**PLANNED UNIT DEVELOPMENT
& SUBDIVISION STAFF REPORT****Date: October 2, 2008**

DEVELOPMENT NAME American Red Cross Subdivision, Resubdivision of and Addition to Lot 3

CONTEMPLATED USE Planned Unit Development approval to allow shared access between three building sites, and Subdivision approval to create three legal lots from a legal lot of record and two metes and bounds parcels.

SITE PLAN

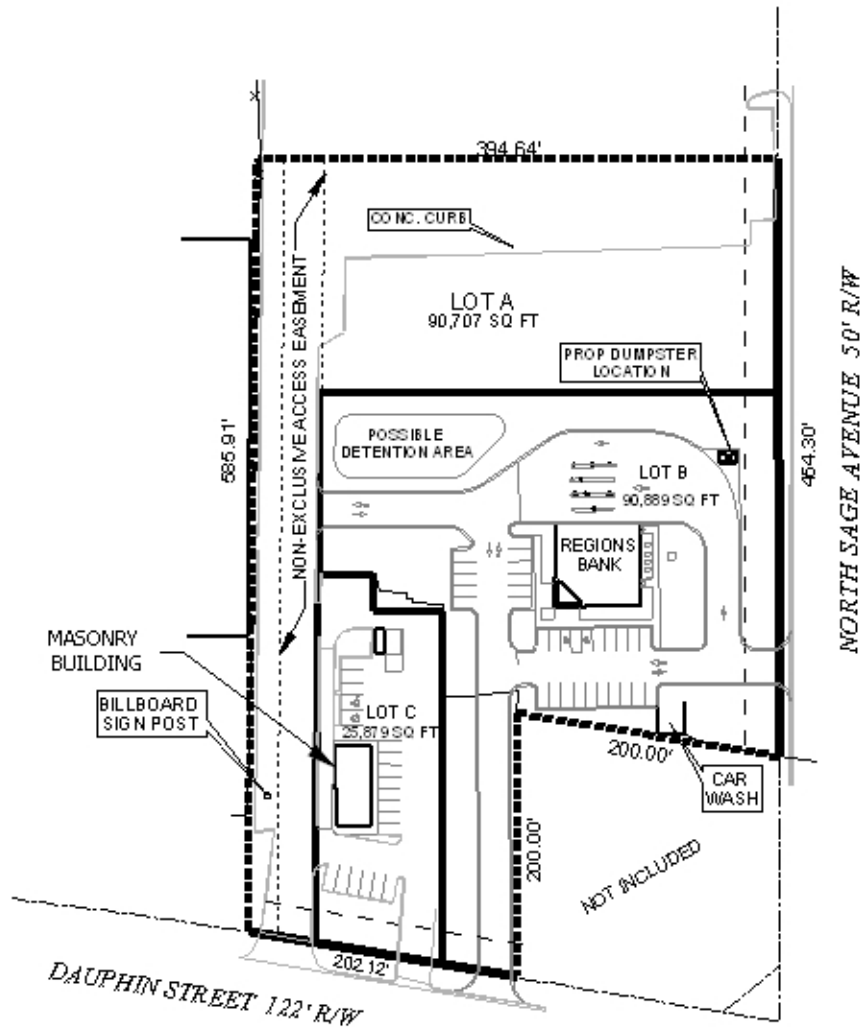
The site fronts onto Dauphin Street, a major street, with a right-of-way illustrated as 122-feet, North Sage Avenue, a minor street, with a right-of-way of 50-feet. All streets meet the right-of-way widths as required by the Major Street Component of the Comprehensive Plan. Because of the redevelopment of the site, access management is a concern. Lots A & B should be limited to one curb-cut each onto Sage Avenue and Dauphin Street (non-exclusive access easement), Lot B should be limited to one curb cut to Sage Avenue, and Lot C should be limited to the existing curb cut to Dauphin Street, with the size, design and location of all new curb cuts to be approved by Traffic Engineering, and conform to AASHTO standards. If Lot C is redeveloped then access should be limited to the non-exclusive access easement on Lot A to Dauphin Street. It should be noted that the preliminary plat and site plan illustrates an additional curb cut to Dauphin Street for Lot B, which should be eliminated due to Lot B is allowed access to a non-exclusive access easement that provides access to Dauphin Street from the proposed Lot A.

The site illustrates the proposed building, and parking spaces; however, trees or landscaped areas are not illustrated: the site must be brought into compliance with the Zoning Ordinance, including the provision of trees, landscaping, and parking ratio for each intended use.

- 1) placement of a note on the site plan stating that PUD approval is site plan specific, and that any changes to the site plan, will require a new application to the Planning Commission;
- 2) revision of the site plan to place the requirements of Section 64-6.A.3.c., *Lighting*, as a note on the site plan: *"If parking areas contain ten (10) or more cars, lighting shall be provided and maintained during their operation, and shall be so arranged that the source of light does not shine directly into adjacent residential properties or into traffic."*
- 3) revision of the site plan to depict compliance with the tree and landscaping requirements of the Zoning Ordinance; and
- 4) full compliance with all other municipal codes and ordinances.
